# Staff Report BZA23-002-VA

## Blue Beacon Parking | Color | Landscaping

Meeting Date: July 6, 2023

**Docket BZA23-002-VA Blue Beacon Parking, Color, and Landscaping Variances.** The applicant is requesting four Variances to construct an approximate 14,871 square foot truck wash use on the northeast side of Indianapolis Road. The applicant is proposing (1) 38 parking stalls where the maximum is 14.8; (2) using a bright color as a primary façade color rather than an accent; (3) plantings street trees further than 25 feet from the right-of-way; and, (4) relocating bufferyard plantings to other locations on site. The applicant is Blue Beacon International, Inc. on behalf of the owner Whitestown Crossing, LLC.

**Exhibit A**  
N.T.S.

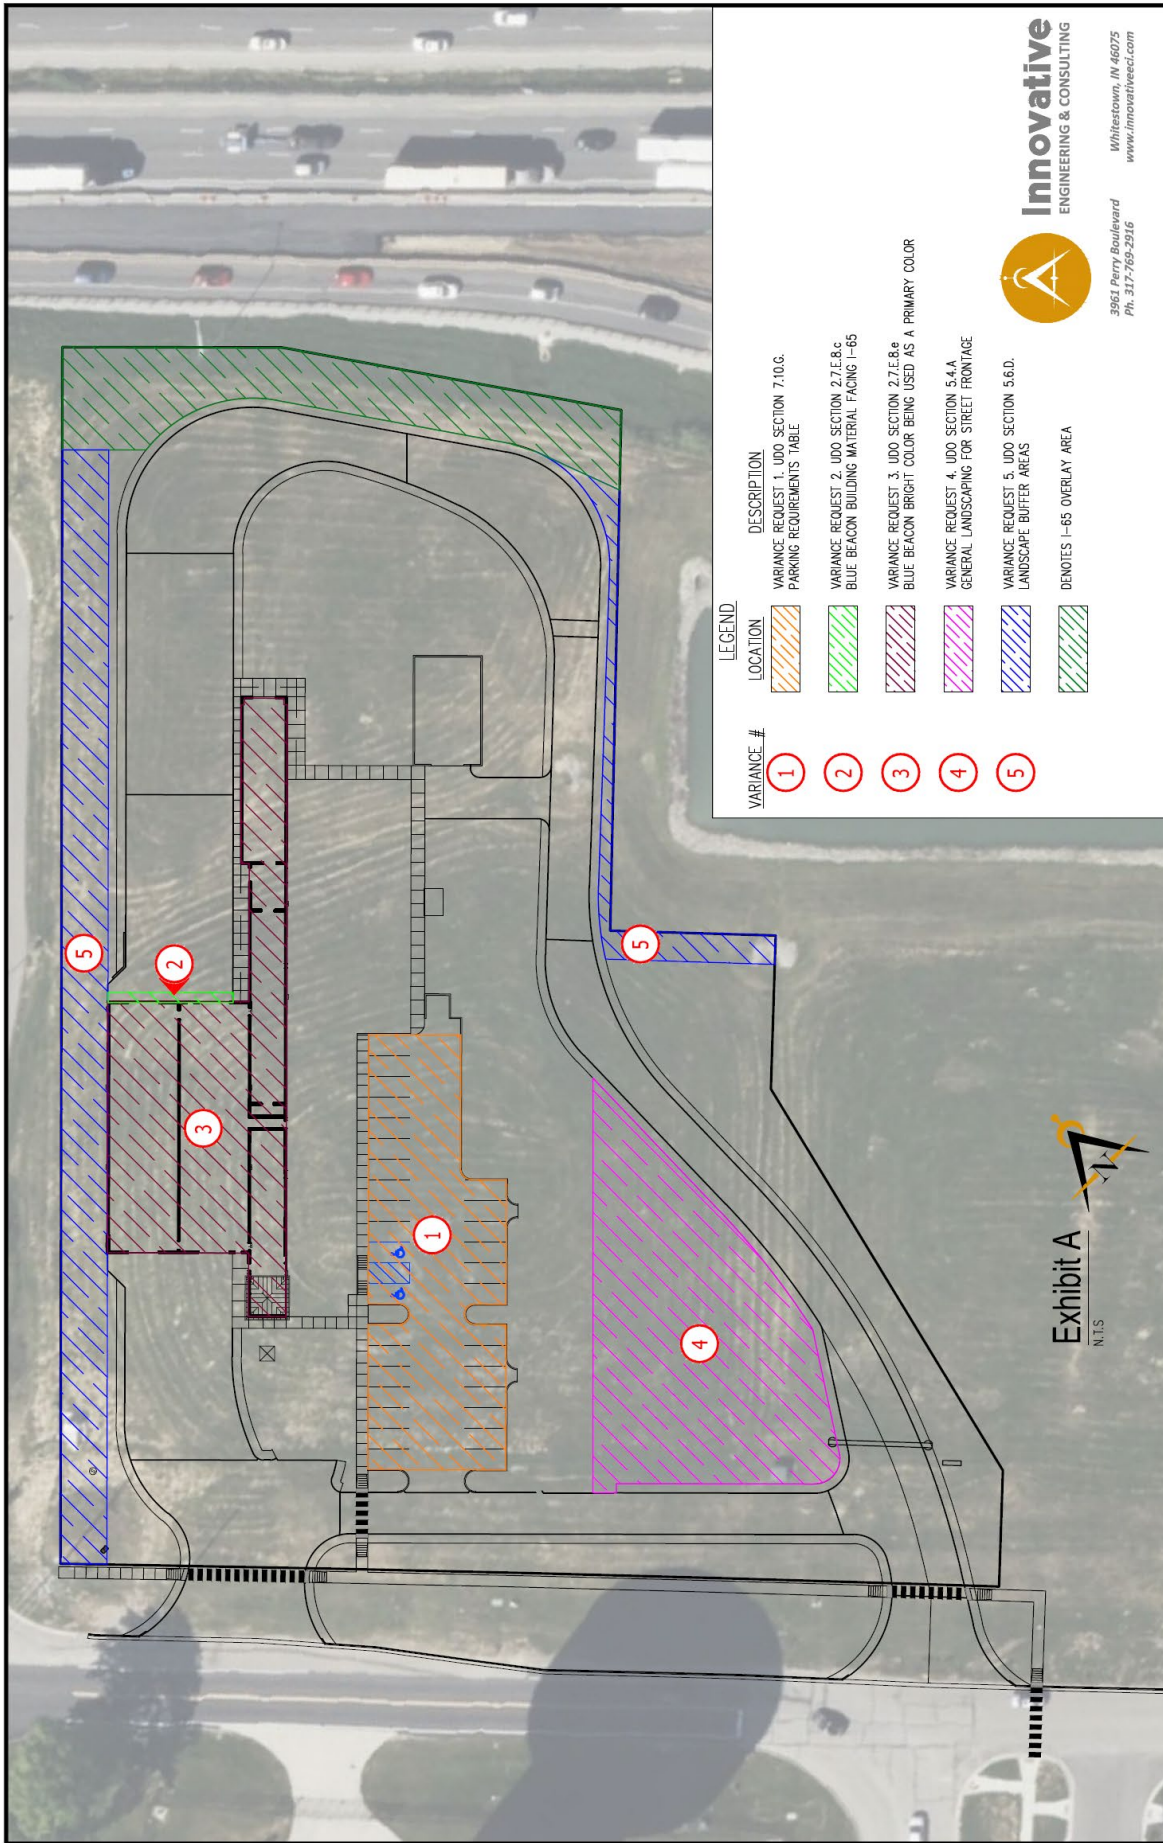
The applicant is proposing to plant the required street trees along Indianapolis Road a distance of greater than 25

feet from the right-of-way.

The applicant is required to provide the buffer to the north adjacent to Timpte. The applicant is proposing to relocate some of the required plantings to other locations on site.

We are requesting that the required street tree plant material be relocated to the green space north and east of the easements. The number of trees to be installed will meet the current UDO Article 5.4 section A. requirements.

There are site exclusive utility easement constraints running parallel to Indianapolis Road that prevents the required street tree planting within the required 25-foot limit of the Right-of-Way line along Indianapolis Road. These easements include a 30-foot-wide Vectern Natural Gas Mains and a 20-foot-wide Whitestown Utilities for sanitary sewer which is shared for electric transmission with Boone County REMC.

The current Whitestown UDO prohibits the planting of trees and shrubs within any easement. This creates a conflict between the easement and street tree location requirement. This requires that the required street trees be relocated north and east of the Right-of-Way line to the closest non-paved area suitable for the proper installation and growth of the landscape plant material.

1. The approval will not be injurious to the public health, safety, morals, and general welfare of the community because:  
***Approval of the variance will not be injurious to the public health, safety, morals, and the general welfare because the required landscaping is being relocated to other locations on site. The applicant is proposing a quantity of overall plantings greater than is otherwise required.***

***The strict application of the ordinance makes results in difficulties due to site constraints. There is an existing utility easement that runs the length of the front of the property. The site faces a physical hardship making it practically difficult to comply with the ordinance. The site has two street frontages and multiple easements throughout the property creating a need for the variance request.***

1. The approval will not be injurious to the public health, safety, morals, and general welfare of the community because:  
***Approval of the variance will not be injurious to the public health, safety, morals, and the general welfare because the required landscaping is being relocated to other locations on site. The applicant is proposing as many plantings along the buffer as feasible given the site constraints without over planting and causing detriment to the plants.***

***The strict application of the ordinance results in difficulties due to site constraints. There is an existing electrical and telecommunications easement that runs the length of the north side of the property. The site faces a physical hardship making it practically difficult to comply with the ordinance.***

**OVERALL COLOR BUILDING ELEVATIONS - PHASE 1**  
**BLUE BEACON OF WHITESTOWN, IN**  
 ??? INDIANAPOLIS ROAD, WHITESTOWN, IN

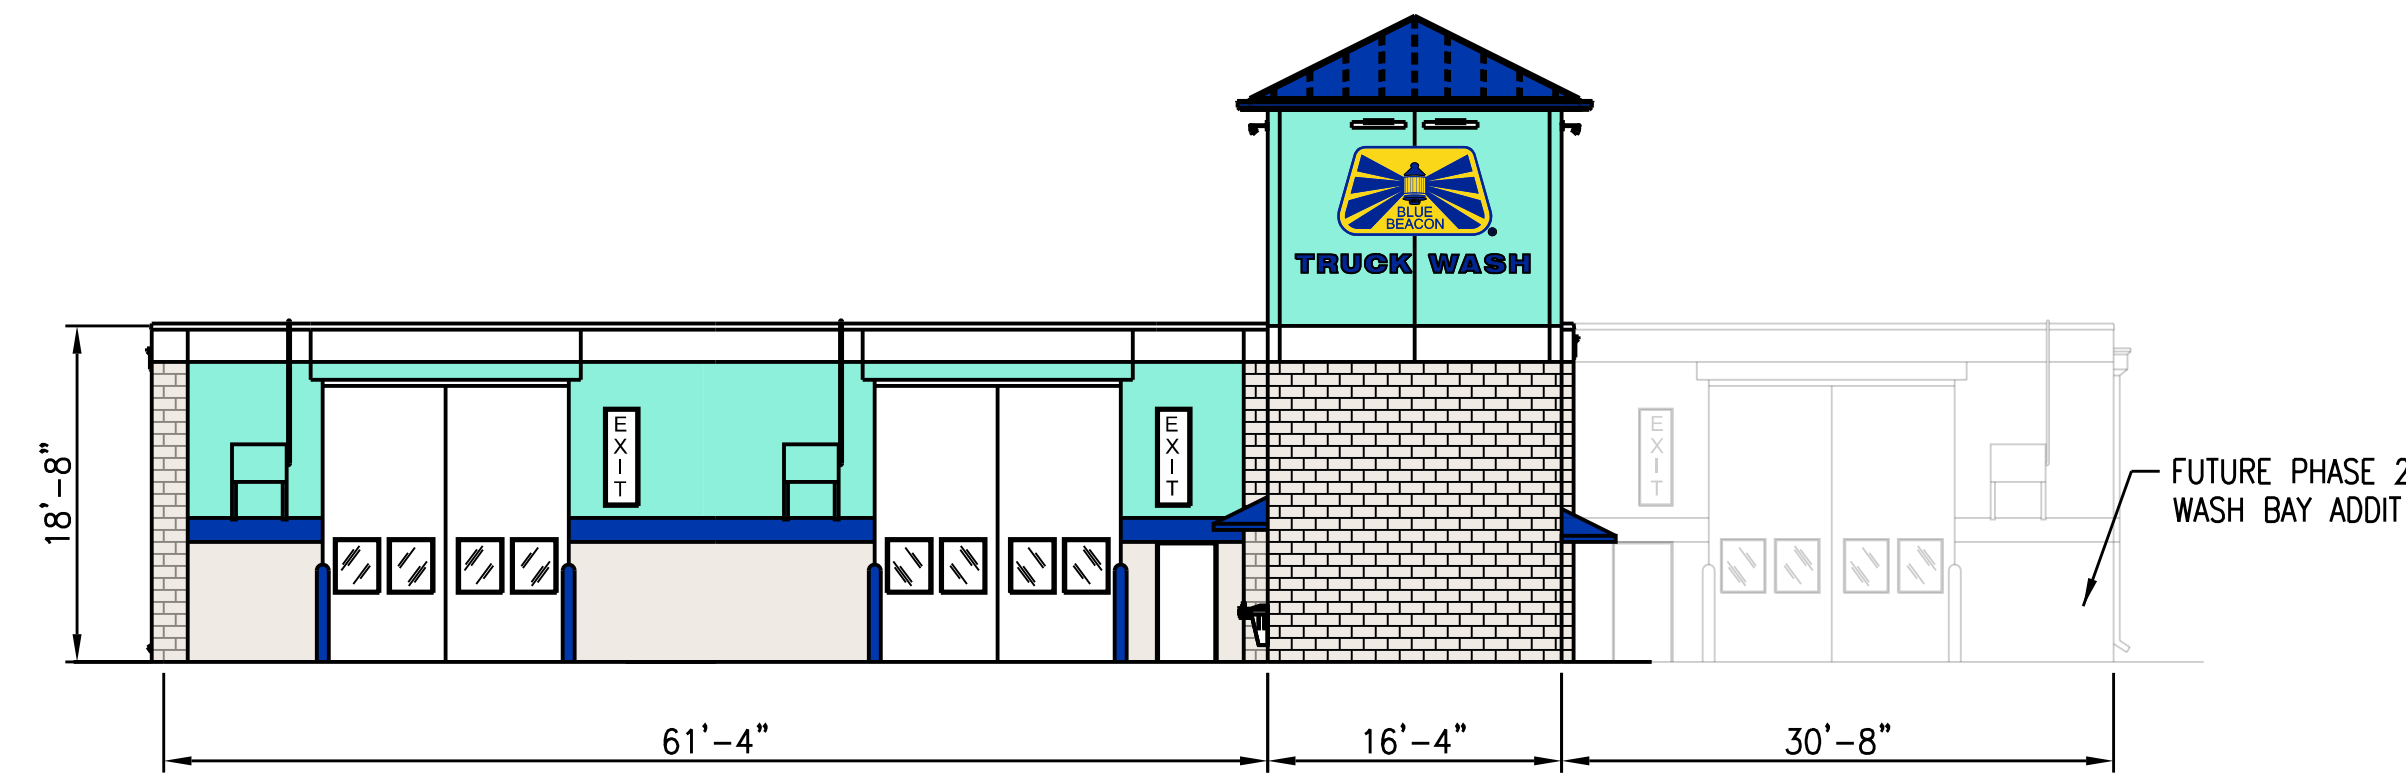
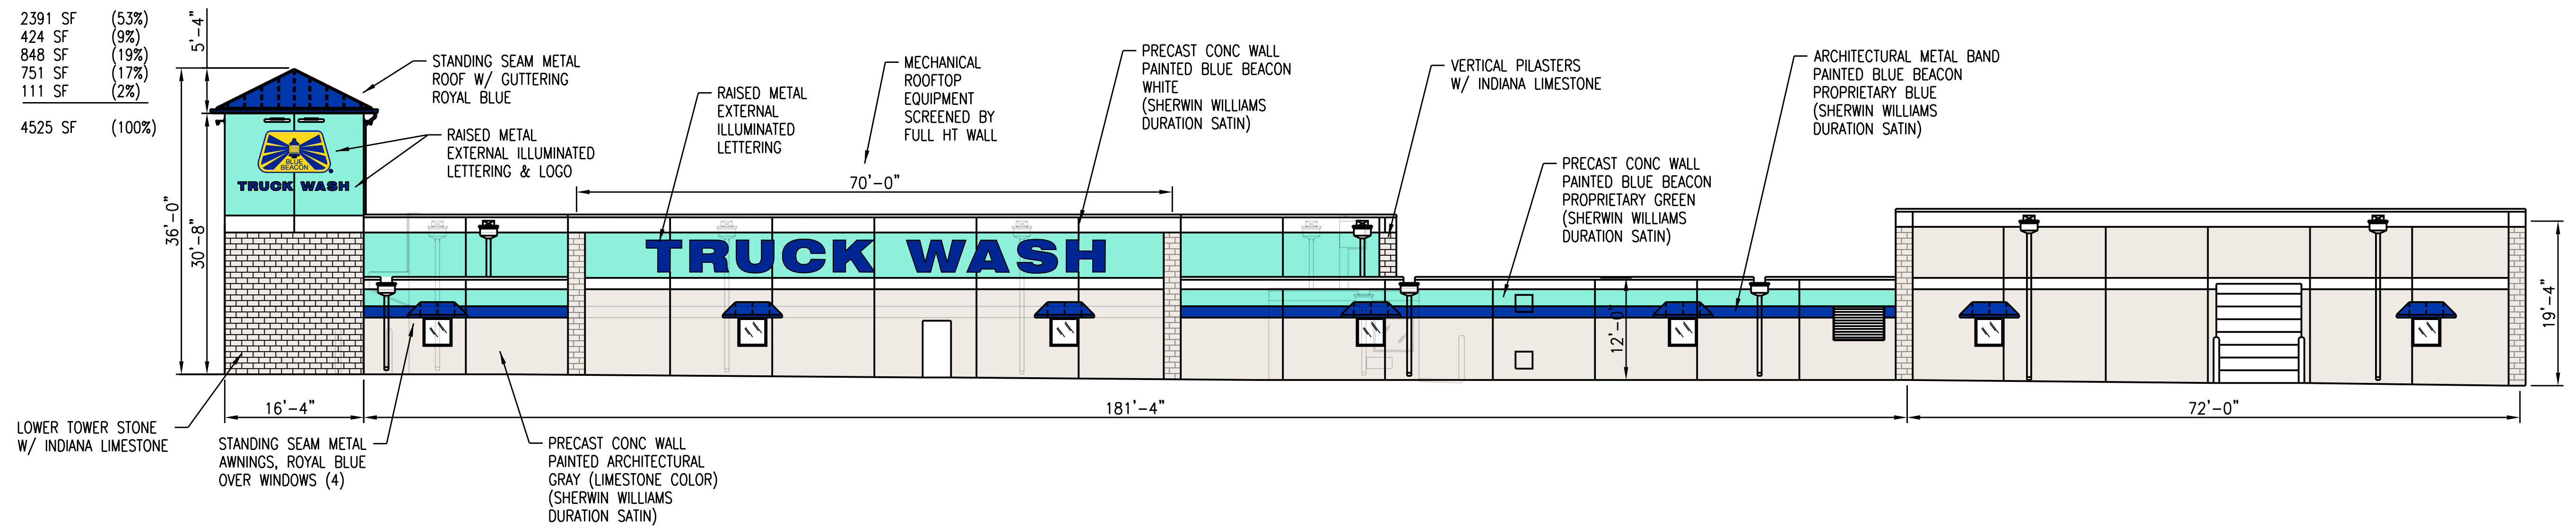
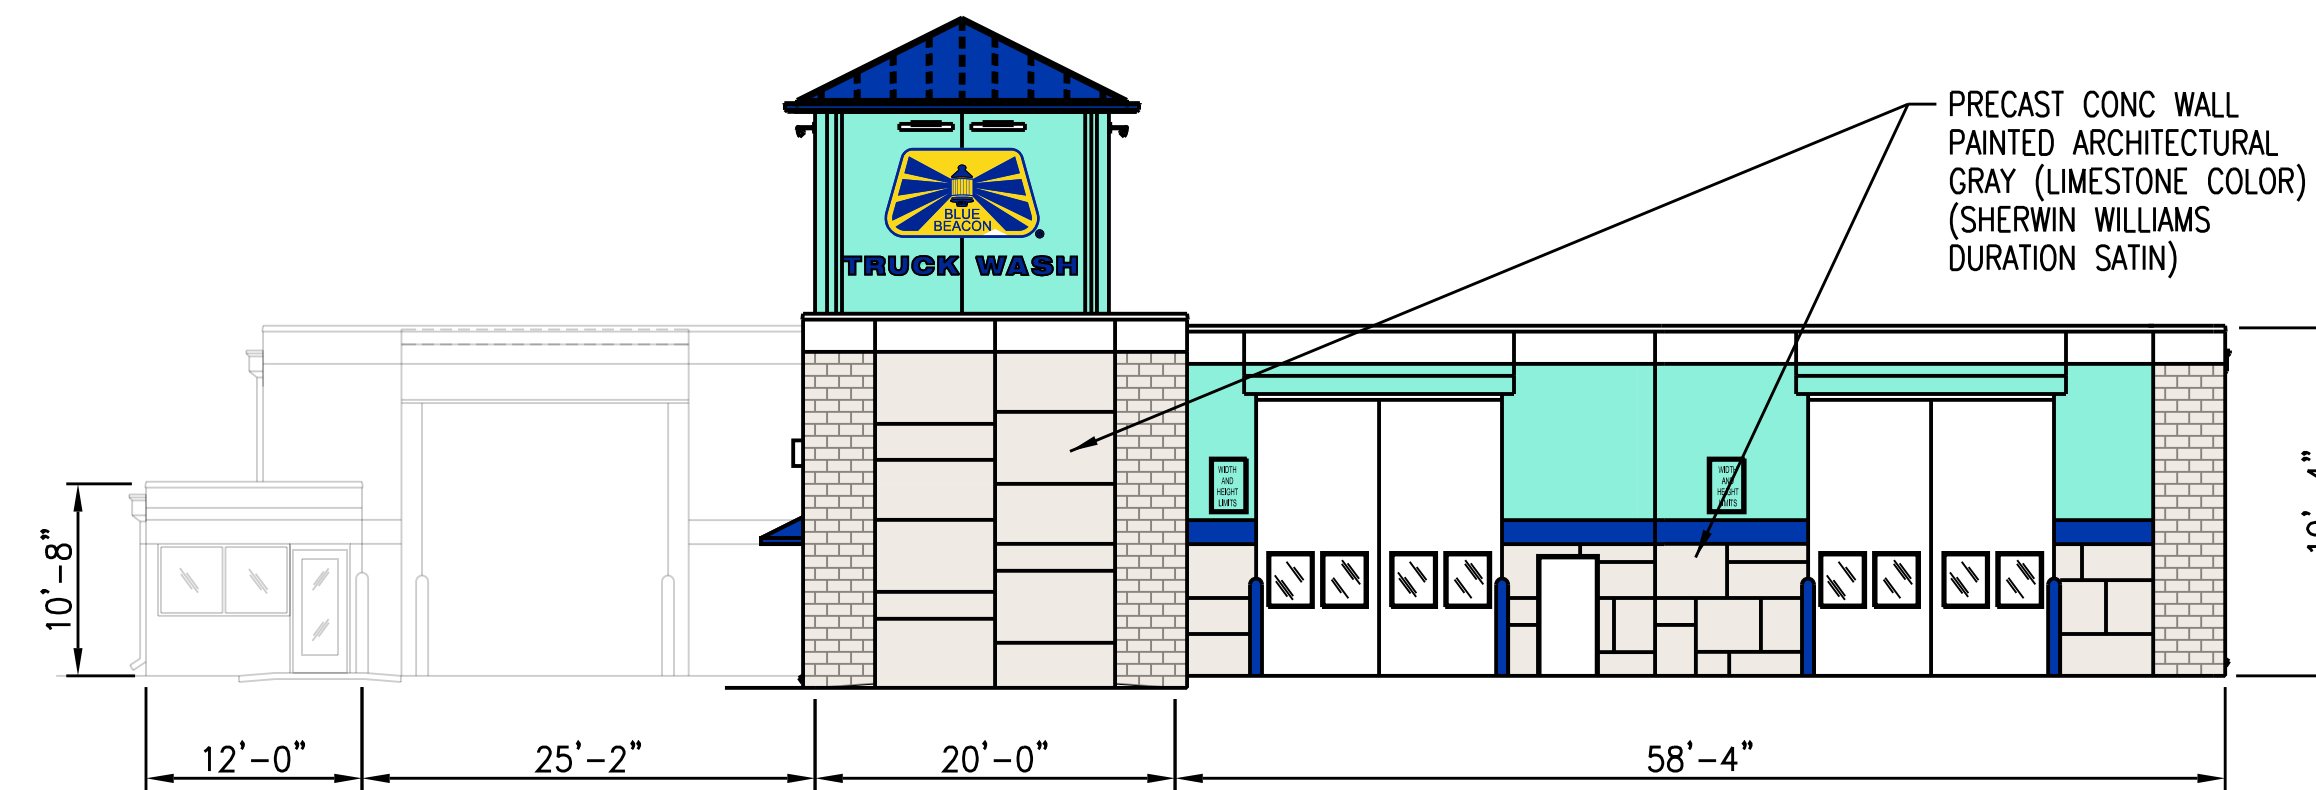
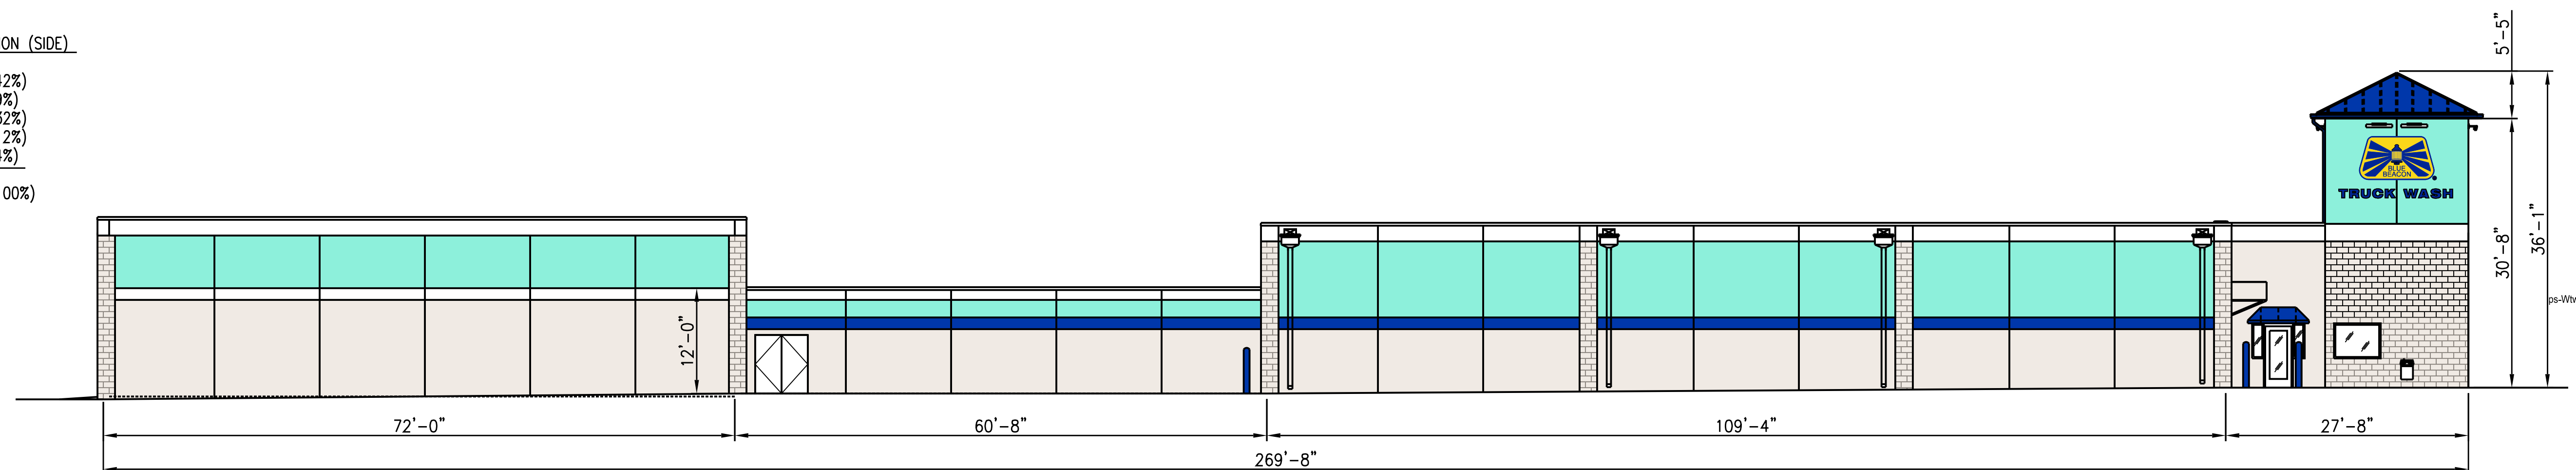
The applicant is using a bright color known as 'BBI green' as a primary façade color rather than an accent.

Staff is providing an unfavorable recommendation for the Blue Beacon bright color being used as a primary color Variance docket BZA23-002-VA.

1. The approval will be injurious to the public health, safety, morals, and general welfare of the community because:  
***Approval of the variance will be injurious to the public health, safety, morals, and the general welfare because the quantity of bright color may be an unsafe distraction to drivers traversing through the community. The intent is to capture truck driver's attention but it may also distract truck and non-truck drivers because it is not a muted color.***

***The strict application of the ordinance does not result in practical difficulties because the desire for the BBI Green color is a desire of the applicant. The site faces no physical or peculiar conditions that would require the building to utilize an accent color as a primary color. While the UDO does not define what an accent color is, under the Legacy Core District an accent color is noted as a maximum of 10% of the building façade.***

If the Board of Zoning Appeals approves Variance Request 2, staff recommends either placing a maximum percentage of BBI Green color that is permitted on each façade or the Board can approve the elevations as presented.
